Bi-colour lead frame change

PCN Number	PCNTOP2606
Publication Date	26/06/2024
Effectivity Date	Immediate effect
Change Summary	Lead frame change
Last Time Buy	N.A
Last Time Ship	N.A

Dual-die product :	Now	After
Lead Frame Appearance		
Final product Appearance

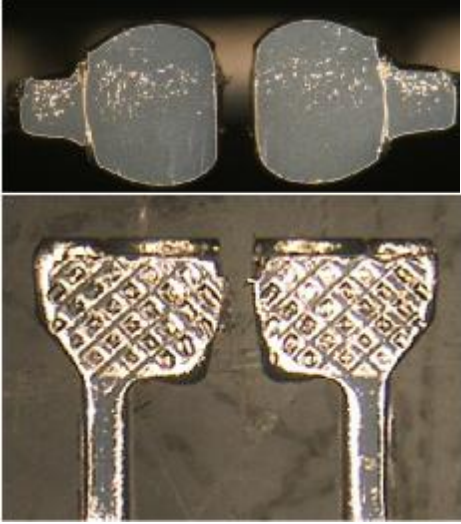
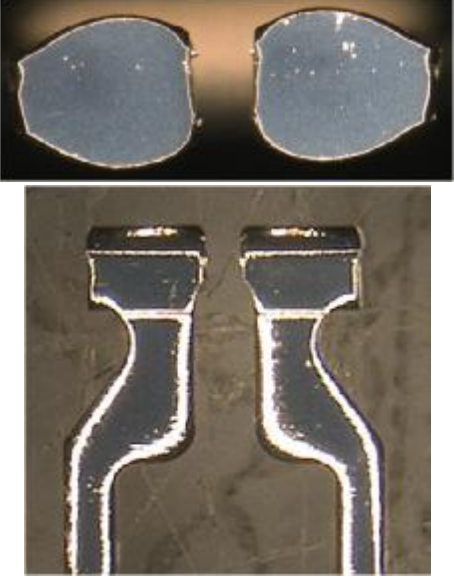
There are differences in the size and appearance of the die and wire bonding areas on the head of the new lead frame. Comparison images are provided in the attached document.
